**Re: 459 US Route 1 - Kittery  
Sketch Plan Application**

**Town of Kittery  
Planning Board Meeting  
December 10, 2020**

**459 U.S. Route 1— Sketch Plan Review / Master Site Development Plan Review**

PROPOSED 4 UNIT MULTI-FAMILY FOR:  
**PAGE AND TRAHAN COMPANIES**  
 ROUTE 1  
 KITTERY, ME 03854  
 DATE: NOVEMBER 10, 2020

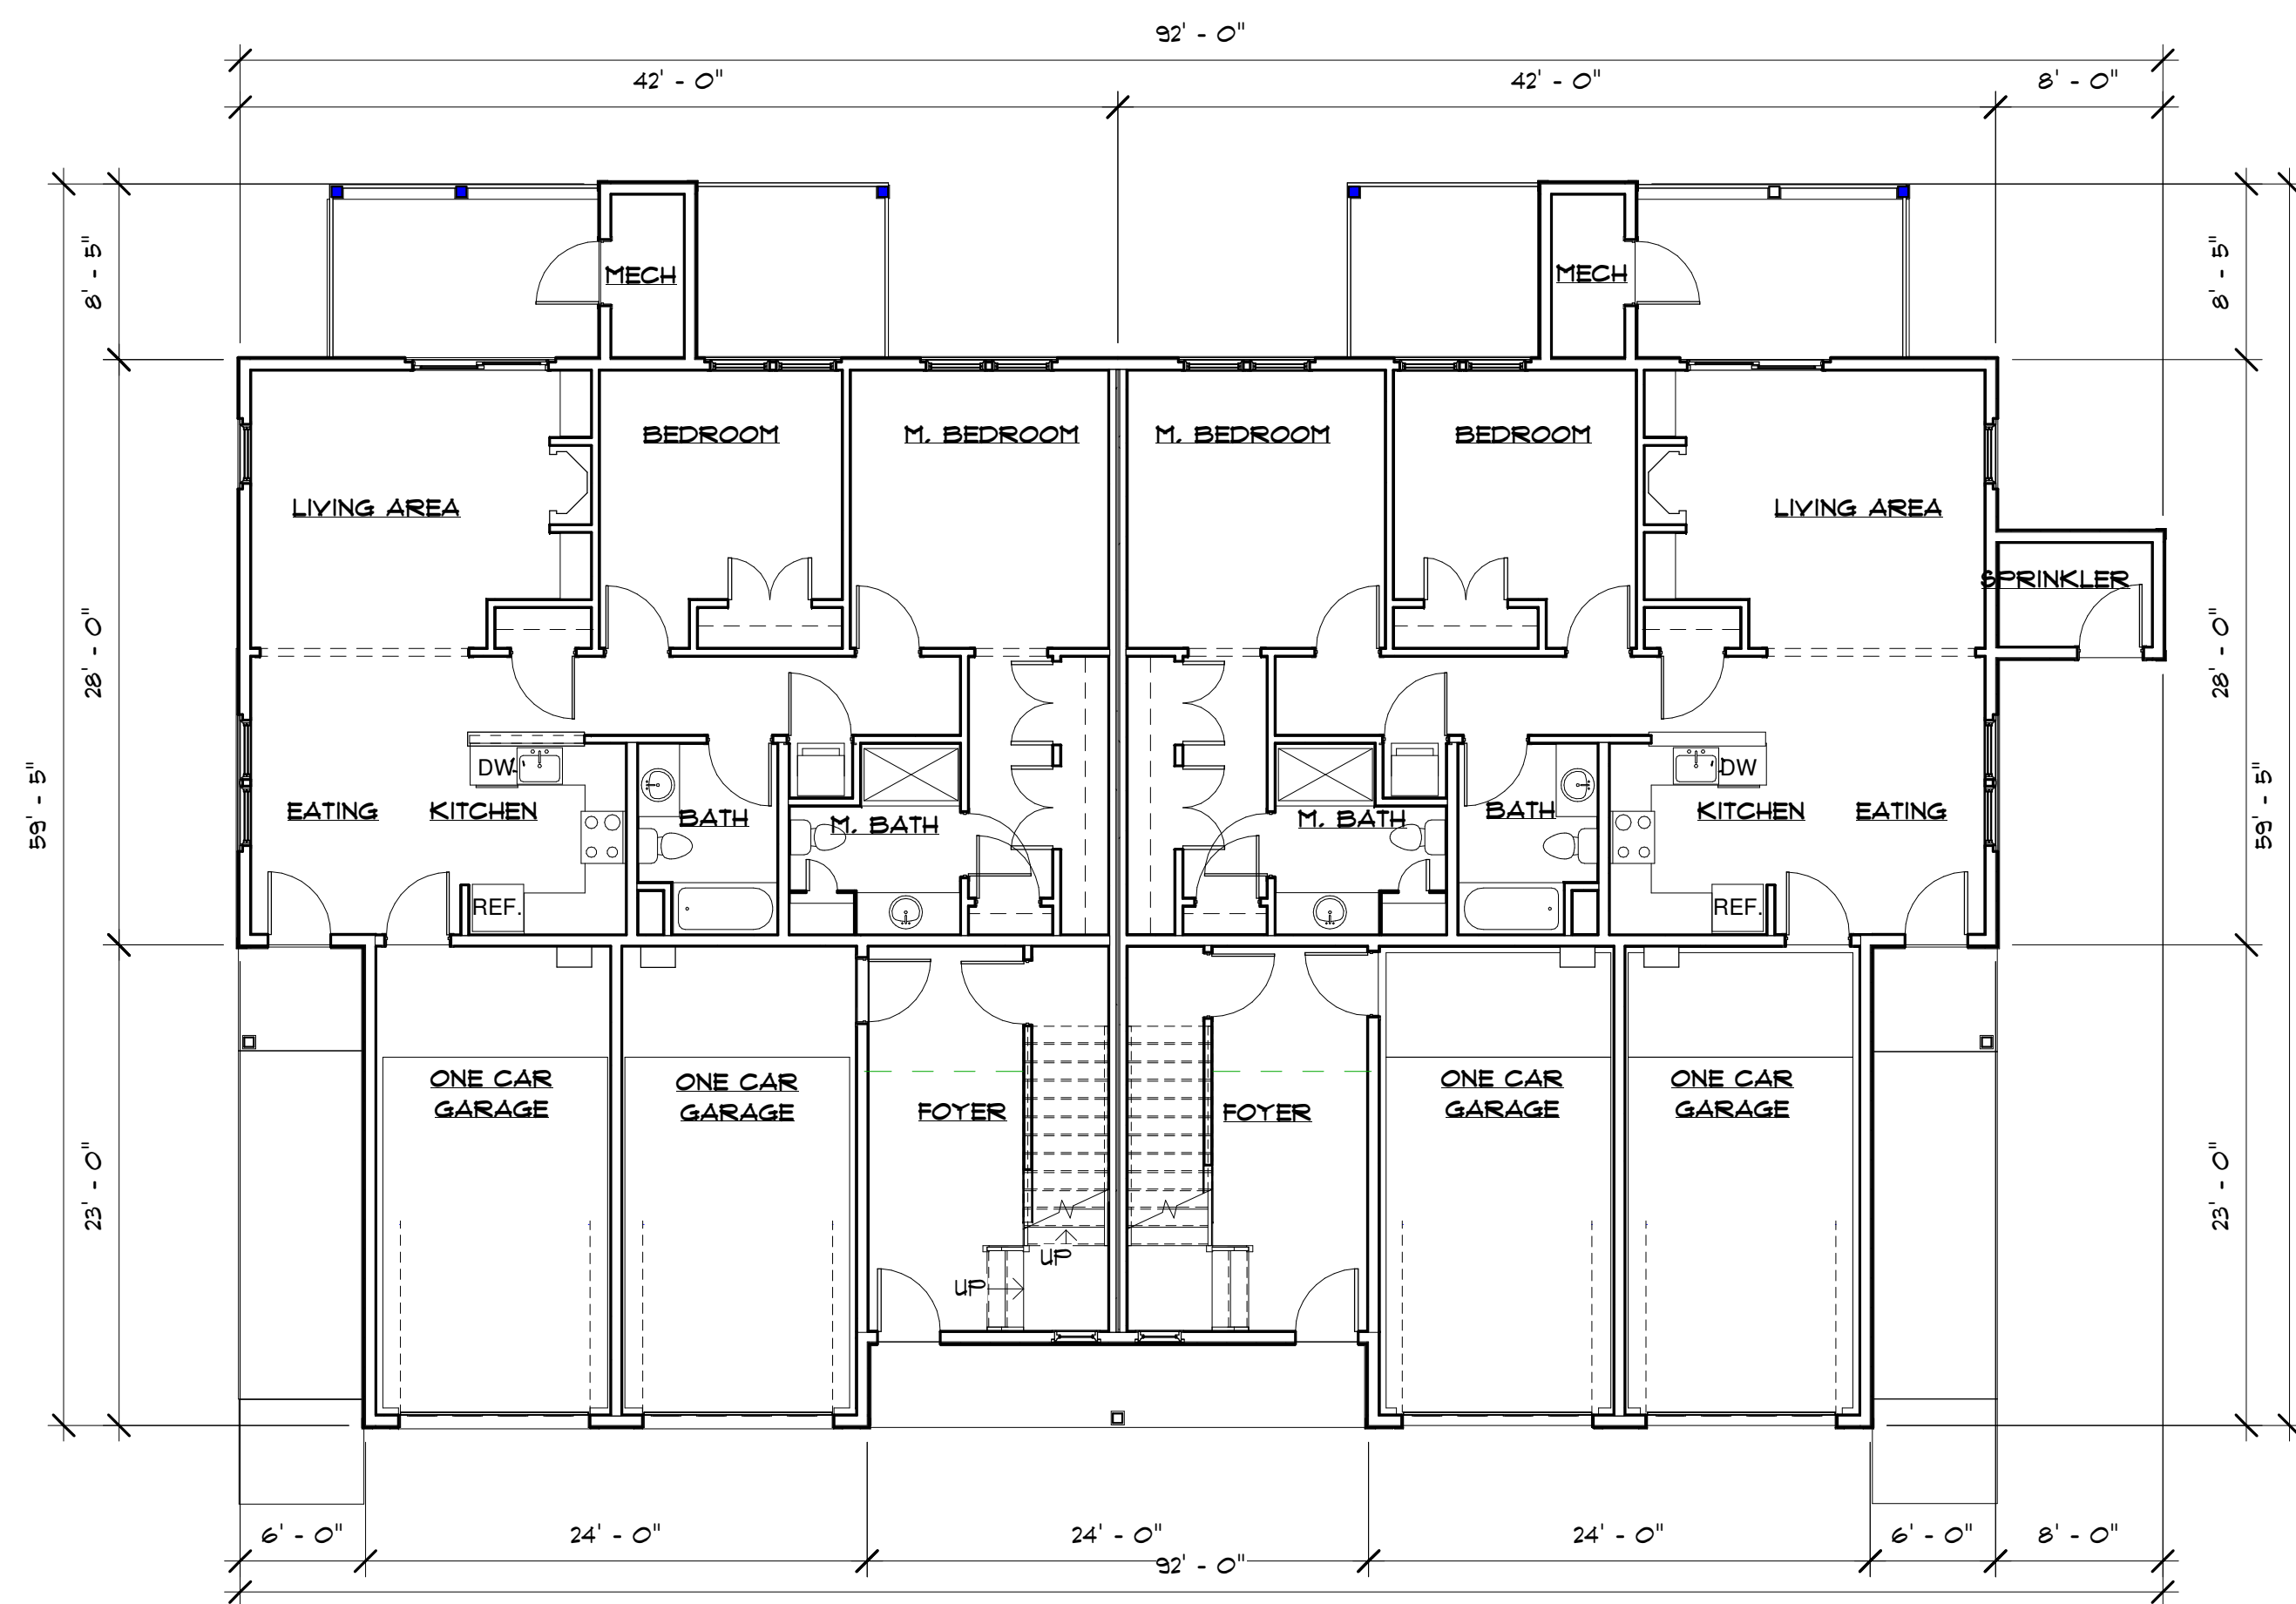
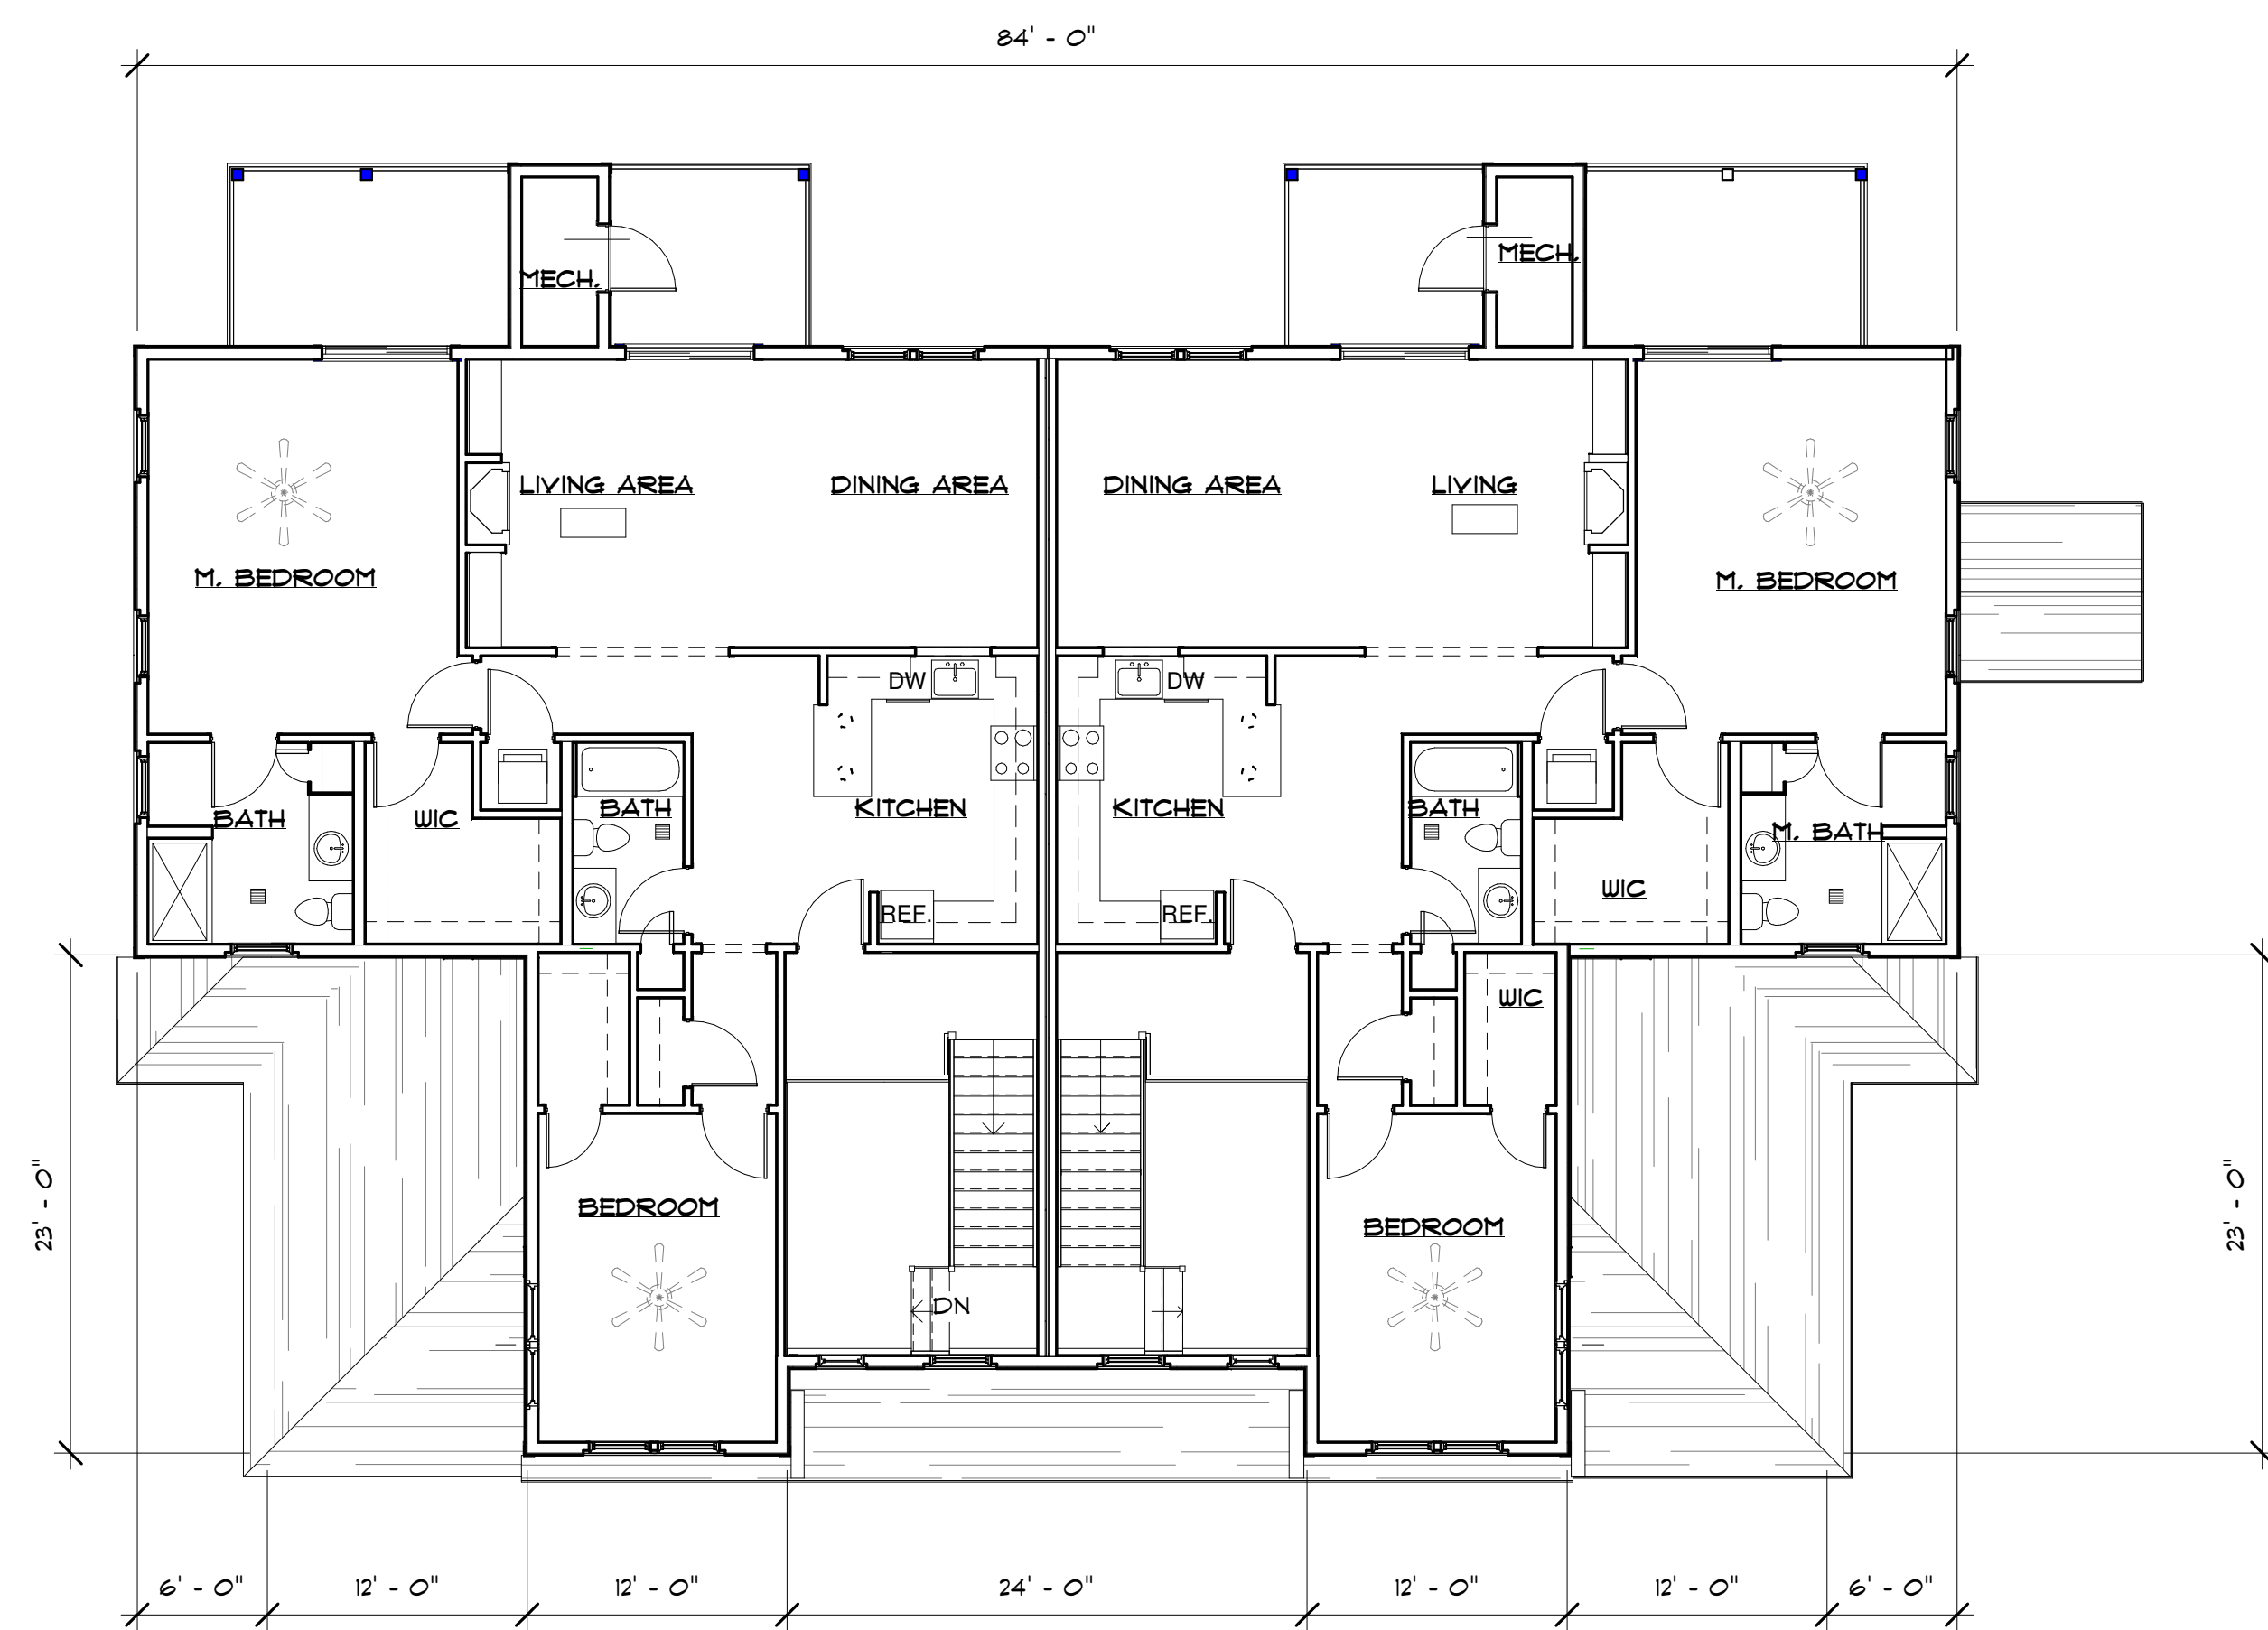
Moving to the question on density, it appears, based on the net residential calculation and density standards for the MU zoning district, pursuant to §16.7.8.2 *Net residential acreage calculation* and §16.3.2.13.D *Standards*, the lot provides enough suitable acreage to foster the number dwelling units as proposed. The proposed architectural elevations of the units appear to comply generally with the design standards, pursuant to §16.3.2.13.D(6) *Building Design Standards*<sup>2</sup>, albeit the Board should confirm with the applicant that the proposed roof pitches complies with the standards under §16.3.2.13.D(6)(b) *Roofs*.
